A303 Amesbury to Berwick Down

Deadline 3
8.18 - Comments on Written Representations

Responses to Written Representations

Regulation Number:	Regulation 5(2)(q)
Planning Inspectorate Scheme Reference	TR010025
Application Document Reference	8.18
Author:	A303 Amesbury to Berwick Down Project Team, Highways England

Figure 2. The extent to which scheme objectives had been achieved (by number of schemes)

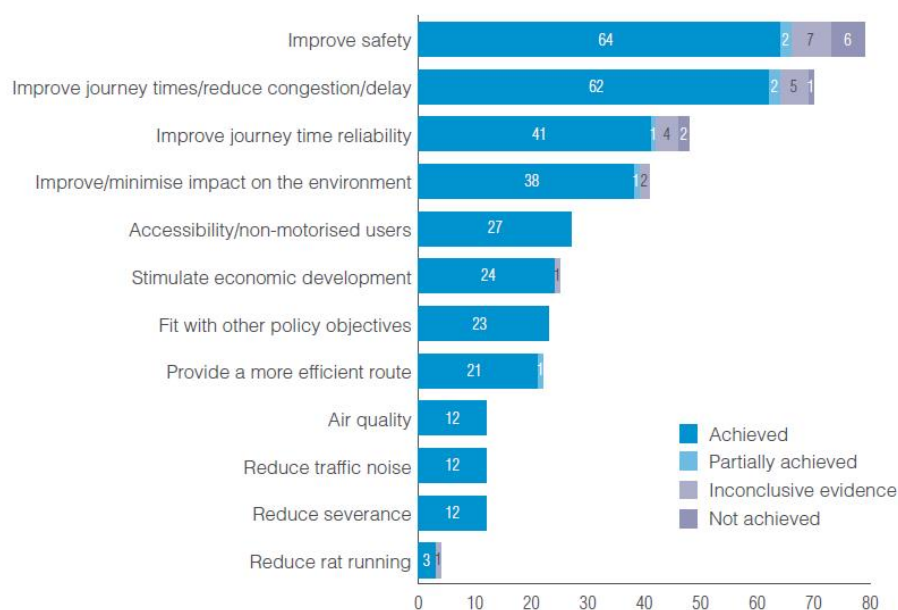
- 16.5.16 Section 5.4.1 of the Stonehenge Alliance Written Representation asserts that only 24% of projects that were examined by the CPRE found evidence that

economic benefits had occurred. The 2017 CPRE report 'The end of the road? Challenging the road-building consensus' is referenced in relation to this assertion. This CPRE report does not include information on how the 24% was calculated, so it is not possible to assess the validity of this figure. The latest Highways England Post-Opening Project Evaluation (POPE) meta insight paper (2019, available at https://assets.publishing.service.gov.uk/government/uploads/system/uploads/attachment_data/file/782823/POPE_Meta_Insight_Paper_2019.pdf and appended to this response in Appendix A) reviews outcomes of 85 Highways England schemes implemented between 2002 and 2014. As shown in the figure reproduced from the POPE report below, 24 of the schemes were able to evidence that they had contributed to the stimulation of economic development, and only one scheme demonstrated inconclusive evidence in the achievement of its economic objectives. It would be a misrepresentation of the data to suggest that only 24% of schemes deliver economic benefits; for schemes with an objective to stimulate economic development, which was then monitored, the data shows that 96% (24 of the 25 schemes) achieved their objective.
